LAND USE DIVISION INTEROFFICE MEMORANDUM

RE: SUBDIVISION REQUIREMENTS - IN THE MATTER OF THE

APPLICATION OF KRAMER PROPERTIES, APN 017-032-003, APPS 9902, FMS 15-004, PDP 15-001, GPA 15-005, AND ZR 15-008 FOR APPROVAL OF A TENTATIVE MAP, CONSISTING OF 81 ACRES INTO 156 LOTS

DATE: 12/27/2021

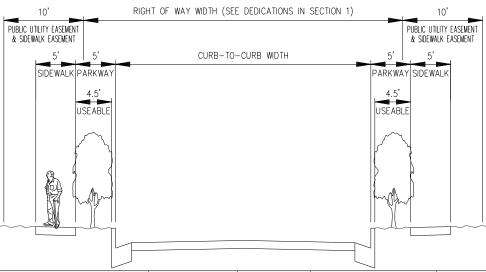
(e) ARBUTUS STREET (OFFSITE): Applicant shall construct in-fill sidewalks along the south side of Arbutus Street between Walnut Street and Cedar Street. Applicant shall construct Class 2 bike lanes on Arbutus Street from Walnut Drive to the subdivision boundary.

Applicant shall construct Arbutus Street from Cedar Street to the subject property. A partial road section shall be constructed consisting (from the south) of 6 foot wide curb adjacent sidewalks, 5 foot wide bike lane, two 12 foot wide travel lanes, and 5 foot wide bike lane. On-street parking is prohibited until such time as parking lanes are added to the road.
